72+COLLINS DEVELOPMENT

CITY OF MIAMI BEACH
DESIGN REVIEW BOARD

MARCH 2, 2021

72 COLLINS HOTEL & CONDOMINIUM
MIAMI BEACH, FL

ELEVATION EAST CORNER FACADE - PHASE 1

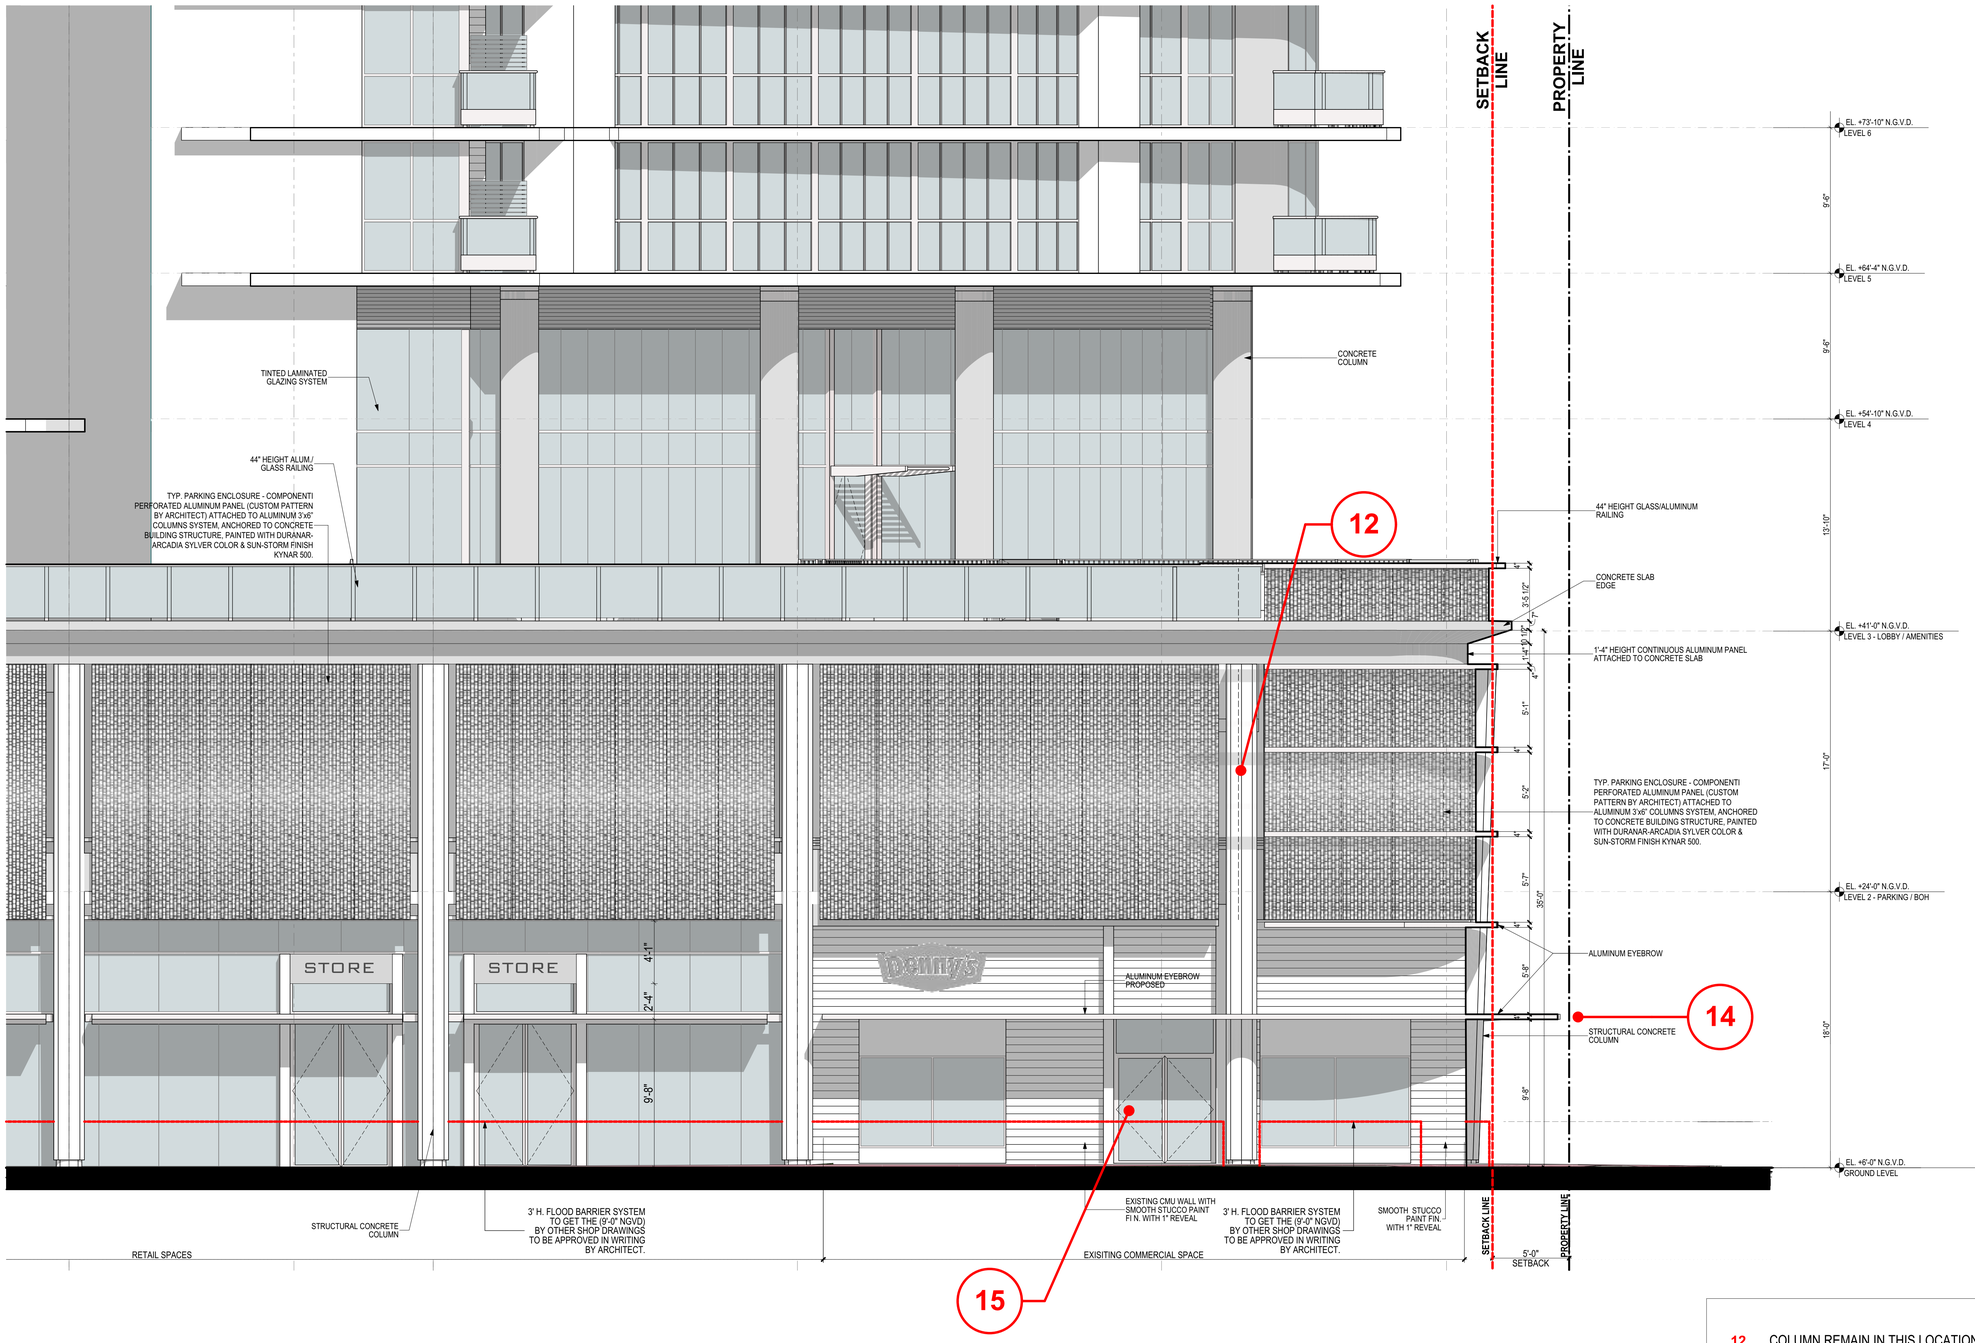
PROPOSED MODIFICATIONS ON PHASE 1

6.	COLUMN RELOCATION
7.	ALUMINUM AWNING/EYEBROW EXTENDED TO MATCH FOOTPRINT OF EXISTING CONSTRUCTED AWNING
8.	RETAIL DOOR RELOCATION

ELEVATION EAST CORNER FACADE - PHASE 2

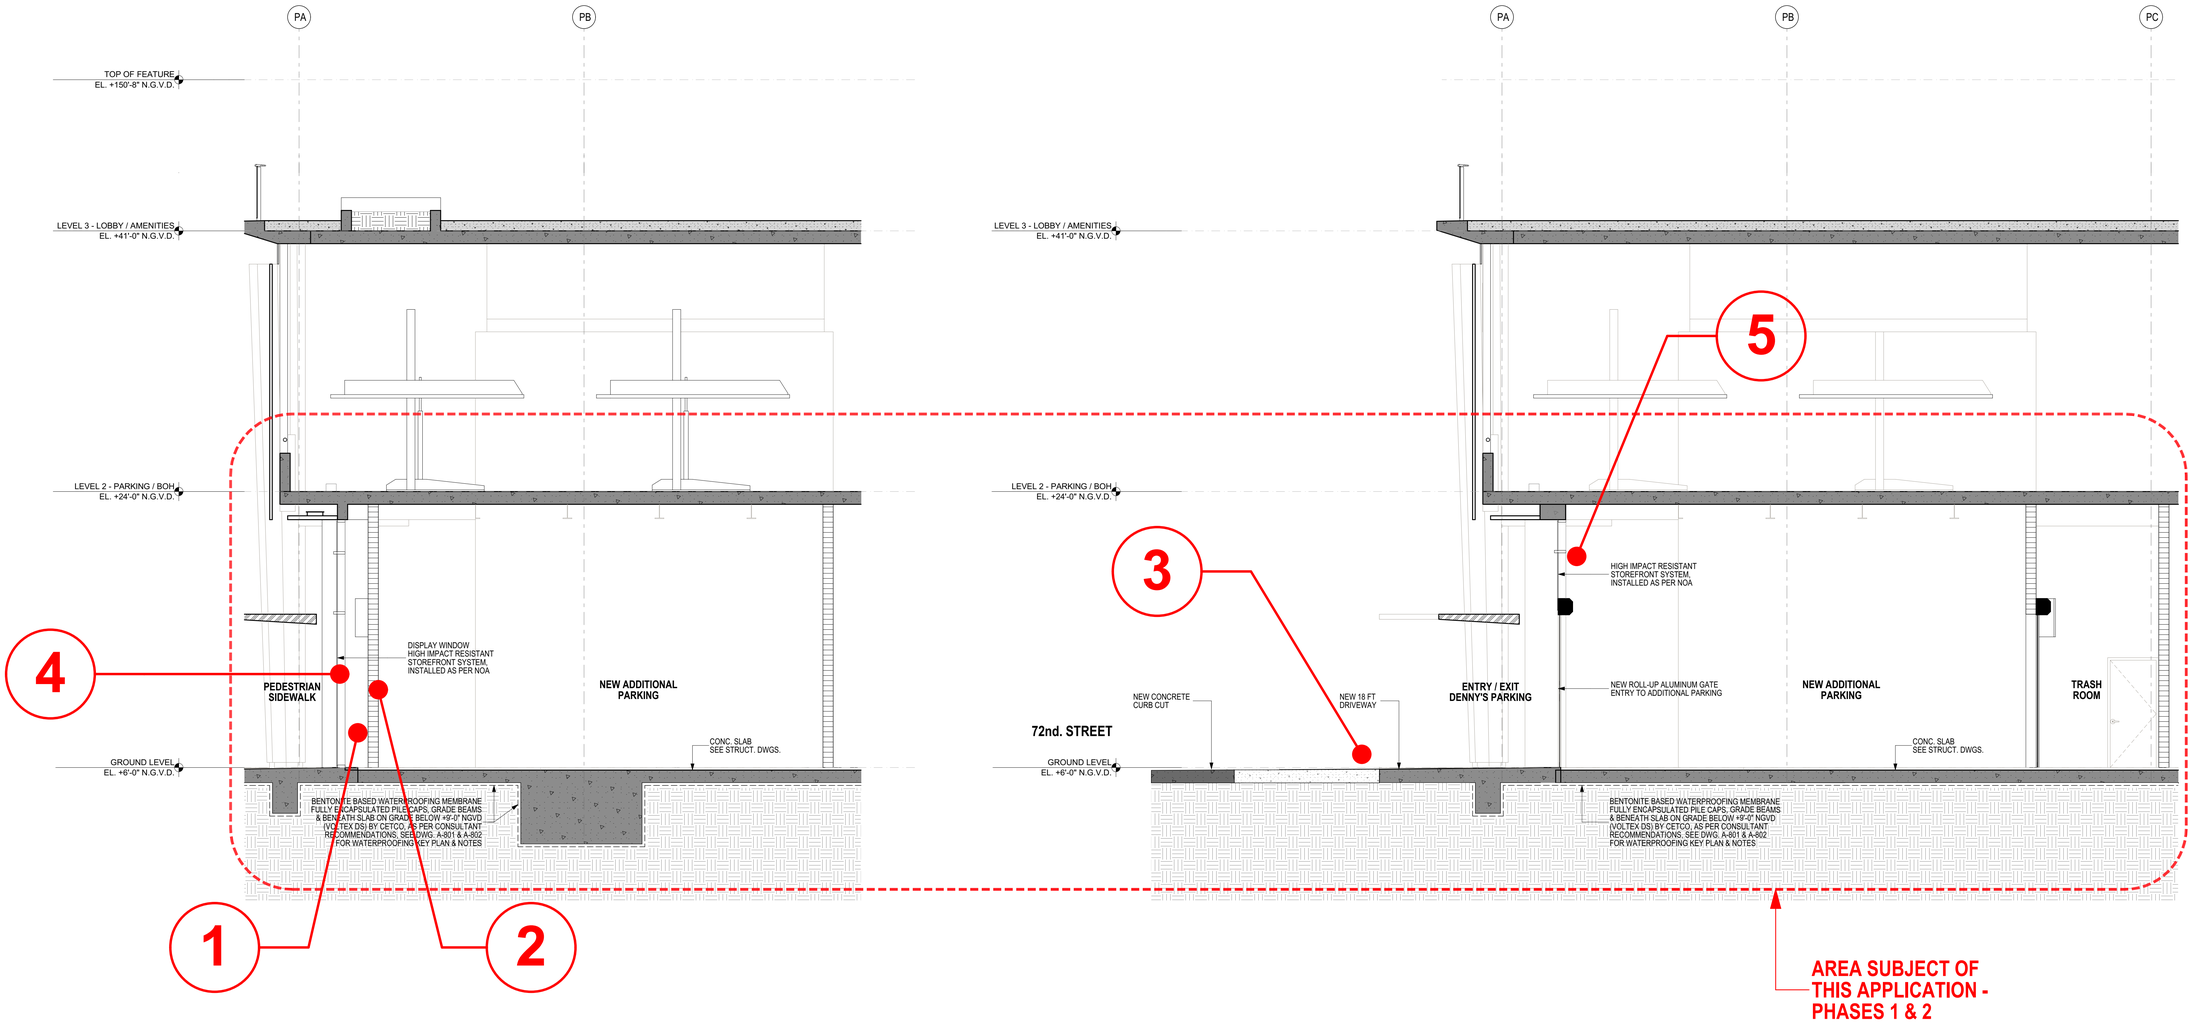
12.	COLUMN REMAIN IN THIS LOCATION
14.	ALUMINUM AWNING/EYEBROW DIMENSIONS REMAIN
15.	RELOCATION RETAIL DOOR

LEVEL 2 / PARKING - PHASE 2

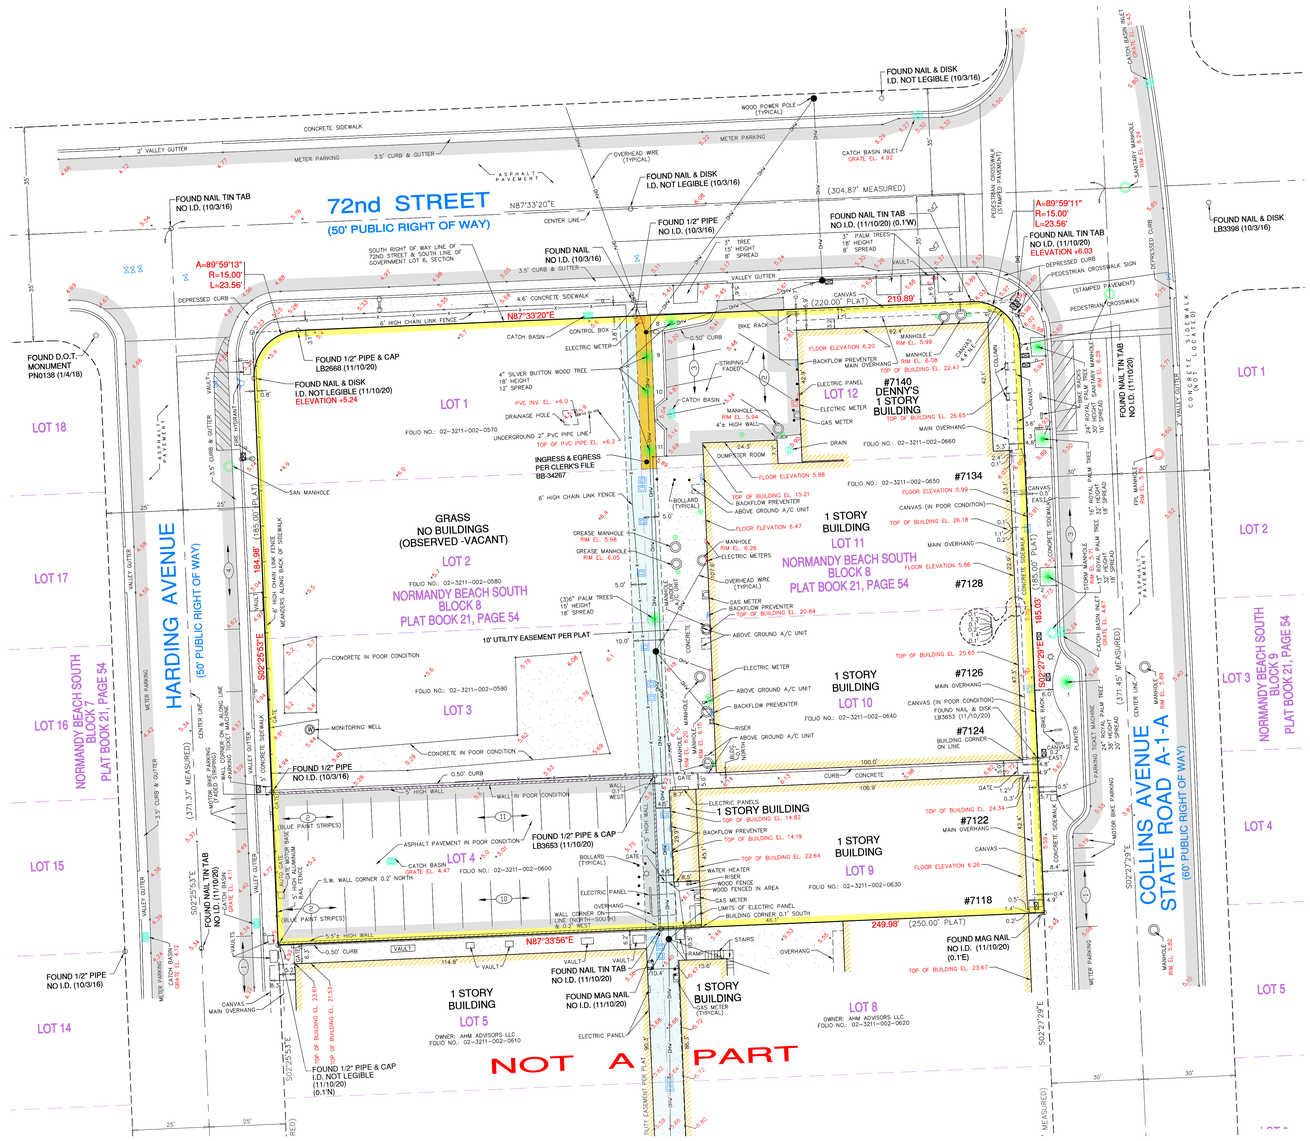
PROPOSED MODIFICATIONS ON PHASE 1 TO REMAIN AFTER PHASE 2

12. COLUMN REMAIN IN THIS LOCATION

14. OPEN TO EXISTING DENNY'S RESTAURANT ROOF BELOW REMAIN

EAST BUILDING ELEVATION - PHASE 2

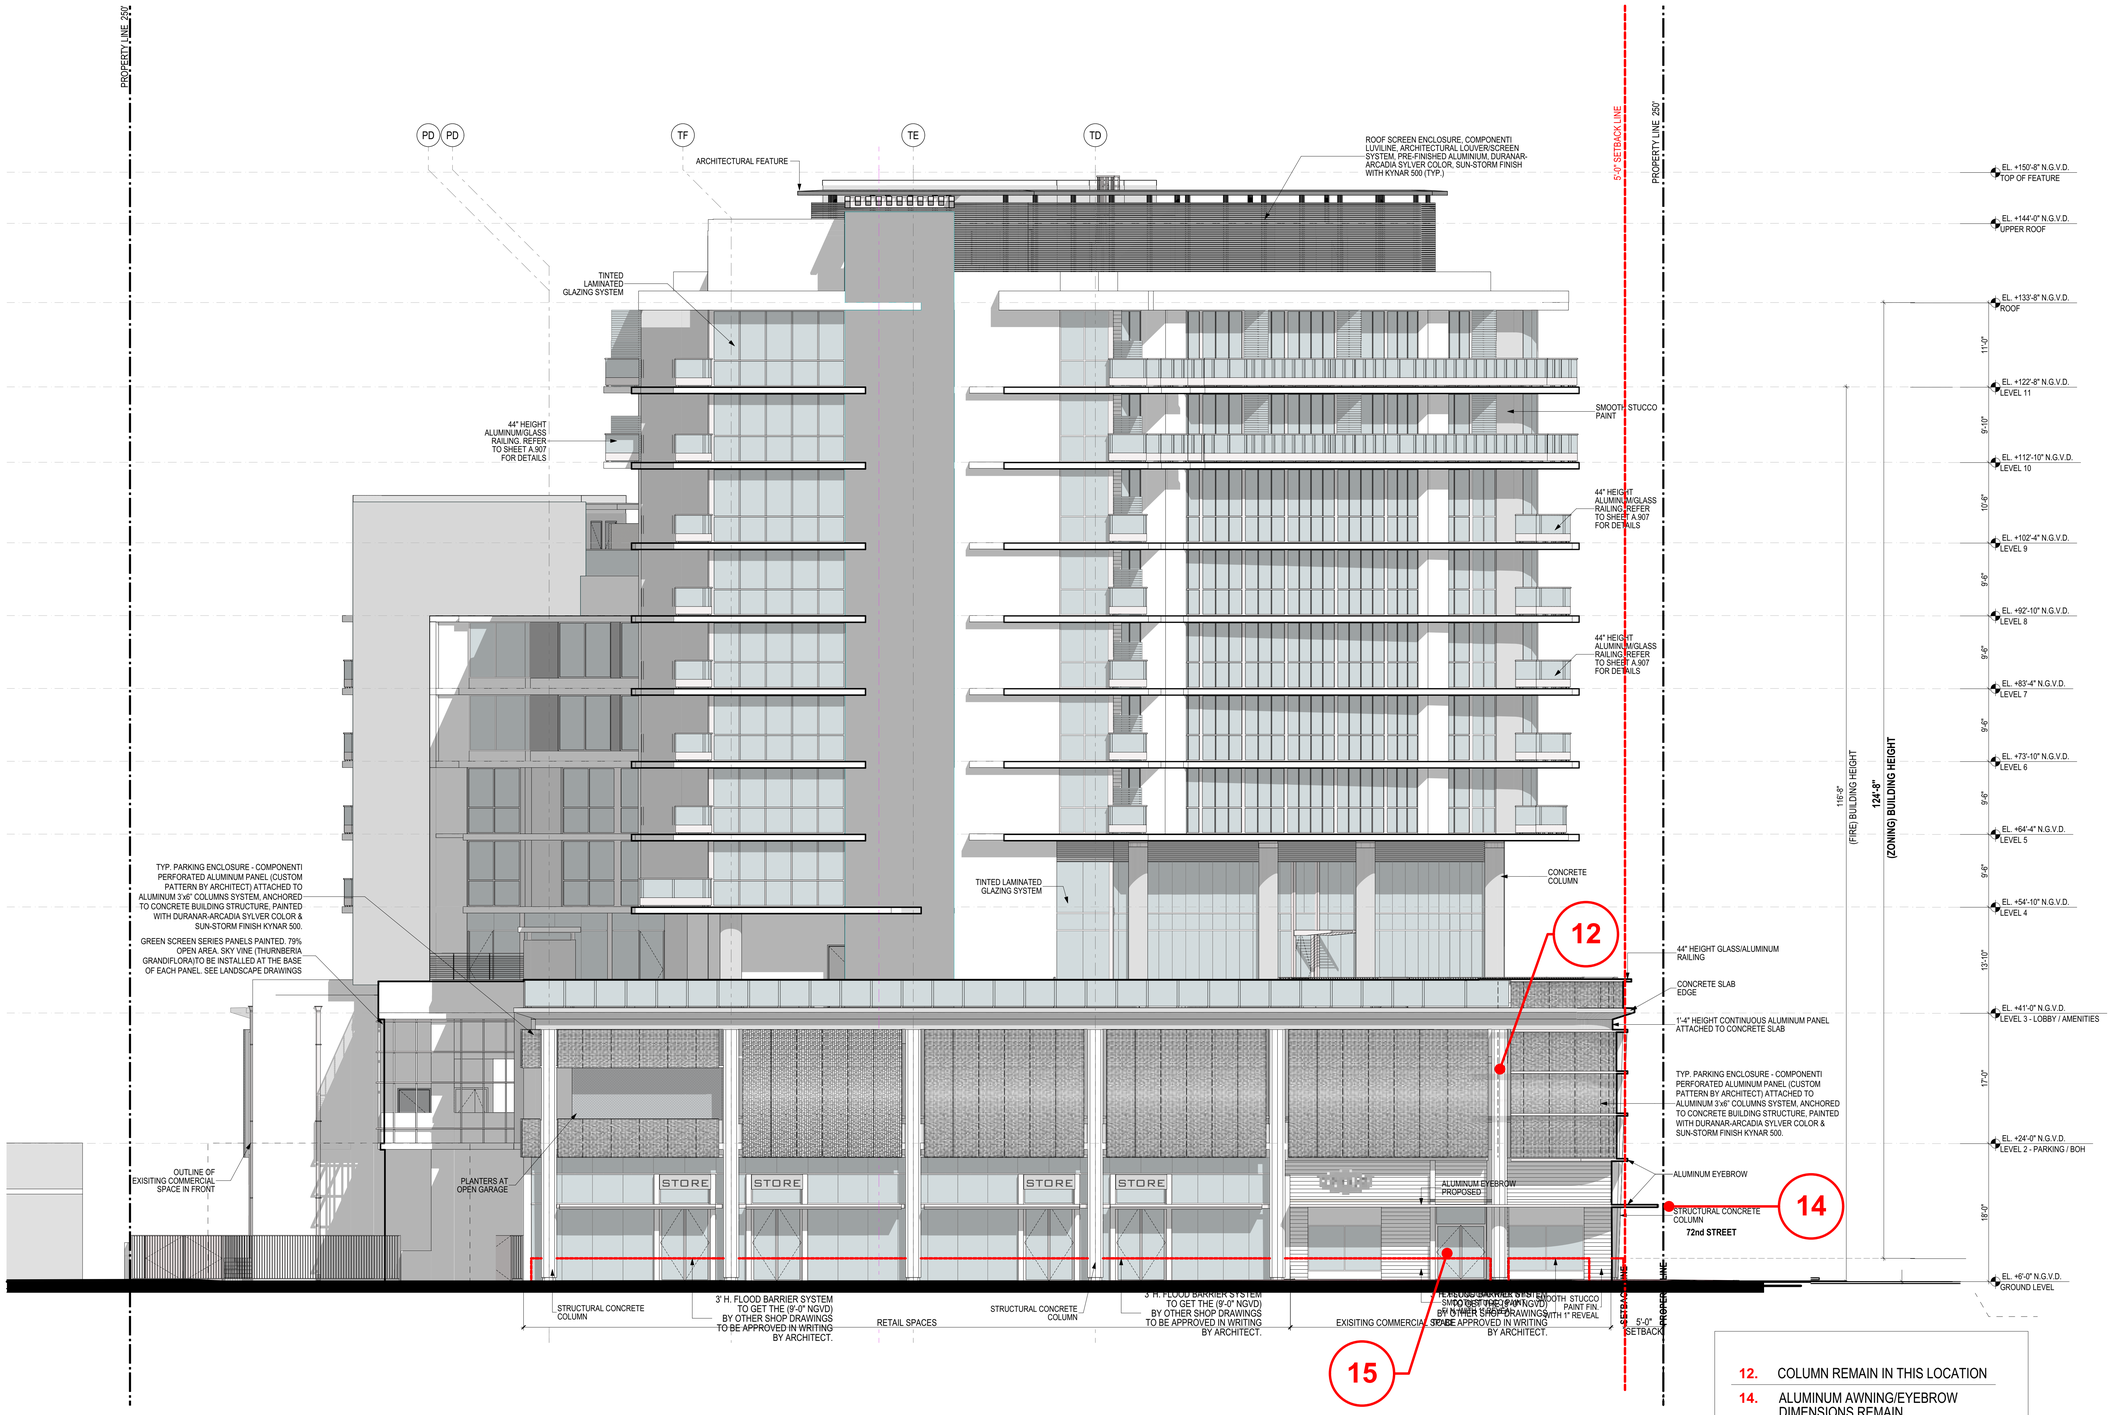
12.	COLUMN REMAIN IN THIS LOCATION
14.	ALUMINUM AWNING/EYEBROW DIMENSIONS REMAIN
15.	RELOCATION RETAIL DOOR
